Service Letter No. 150

July 10, 1950

SUBJECT: Bungee Cable PA-18 "105"

Serial Numbers Affected: 18-60 to 18-133 incl.; 18-135 to 18-162 incl.; 18-176 to 18-180 incl.; 18-182 to 18-196 incl.; 18-198 to 18-202 incl.; 18-205; 18-206; 18-209; 18-210; 18-212 to 18-217 incl.; 18-219 to 18-221 incl.; 18-224 to 18-226 incl.; 18-228; 18-229; 18-231 to 18-233 incl.

BUNGEE INSTALLATION
MODEL PA-'S "105"

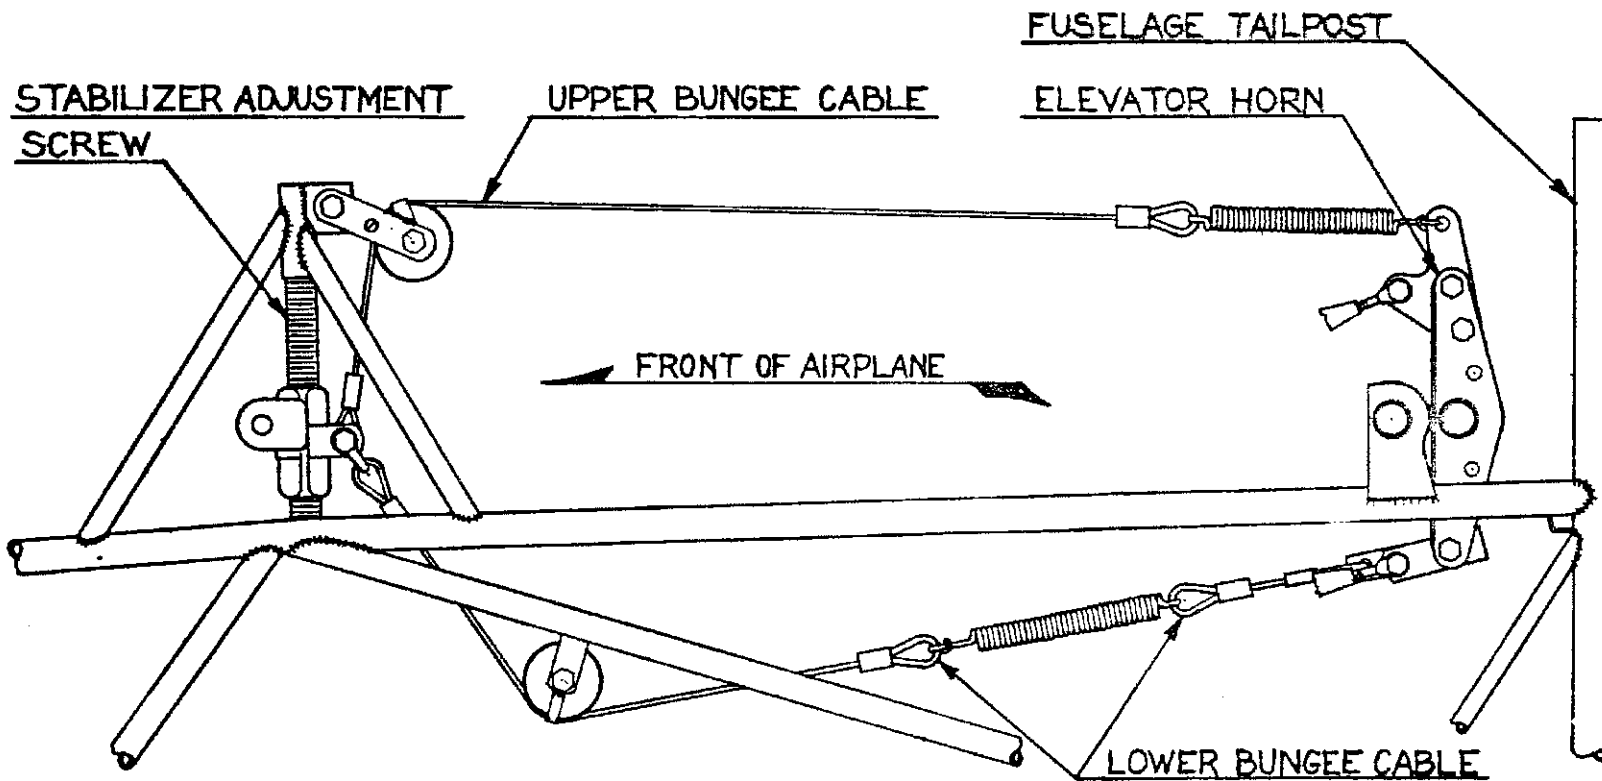
In view of the many comments which we have received from the field, relative to the extremely stiff elevator action on the PA-18 "105" our Engineering Department has issued approval to remove the lower bungee cable, as indicated in the sketch on the reverse side of this letter.

After removal of the lower bungee cable, the proper entry should be made in your log book.
